**CITY OF ALLENTOWN
HISTORIC ARCHITECTURAL REVIEW BOARD
FINAL REVIEW SHEET
February 13, 2018**

ITEM #2 – Case #HDC-2019-00003– Proposal to replace current windows in front of the house which are a violation with vinyl windows to fit the original openings.

Property located at: 415 N Lumber Street

Case # HDC-2019-00002

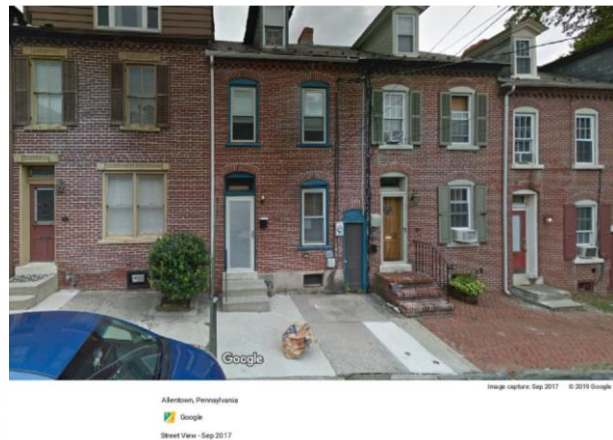
Building description, period, style, defining features: This structure is a 2 ½ story, 2 bay attached brick dwelling with a gable roof, corbeled brick cornice, single roof dormer, 1 over 1 double hung windows (replaced without HARB approval), front door with inappropriate white storm door, and grocer alley door. All masonry openings have segmental arches. The house dates from c. 1887 and is Federal in style with Victorian details.

Proposed alterations: It is proposed to replace current windows in front of the house which are a violation with vinyl windows to fit the original openings.

Guideline Citation: SIS 9. New additions, exterior alterations, or related new construction shall not destroy historic materials that characterize the property. The new work shall be compatible with the massing, size, scale, and architectural features to protect the historic integrity of the property and its environment. **Allentown Guidelines for Historic Districts: 5.** Guidelines for Existing Buildings and Structures, 1. Repairs, Replacement and Alternate Materials, 5. Windows **Evaluation, effect on historic district, recommendations:** Vinyl windows are not included in the potentially approvable replacement windows for primary facades. The existing vinyl windows are a violation. They replaced wood 2 over 2 double hung windows and do not fit the existing masonry openings correctly. New replacement windows should fit the existing masonry openings more closely and should have exterior applied vertical muntins in each sash to recreate the original 2 over 2 appearance. The windows should be one of the approvable materials: wood, aluminum clad wood, smooth fiberglass, or wood composite.

The existing aluminum storm door was approved by HARB but required to be painted to match the existing trim color. This should also be done as soon as weather permits. It is recommended to remove the white mini blinds in the storm door which obstruct the view of the primary door.

Discussion: The applicant said he was willing to install the recommended aluminum clad windows instead of vinyl windows. He also agreed to install the windows with 2 over 2 simulated divided lights as was historically seen on the building and is seen on adjacent buildings. He explained to the HARB that the storm door had been approved by an earlier approval and that the storm door had mini blinds in between the glass layers. He also said the blinds can be raised to the top and that usually they are in that position. The applicant indicated he intended to install windows with a beige color. He also said he would paint the storm door to match the new windows. The HARB explained that was not appropriate; the storm door should be painted to match the trim. After some discussion it was decided that the windows and painting of the storm door would need to be completed by May 1, 2019. Mr. Huber informed that HARB that he had a conflict of interest with the case and would abstain from voting.

1. The proposal to replace current windows in front of the house which are a violation with vinyl windows to fit the original openings at 415 N Lumber Street was presented by Michael Irwin.
2. Aluminum clad wood windows with simulated divided lights in a 2 over 2 configuration will be installed on the front of the house.
3. Each window must fit the exact size of its masonry opening without blocking.
4. The existing storm door will be painted to match the trim color (and not the window color) as required by the earlier COA.
5. The above work will be completed by May 1, 2019.
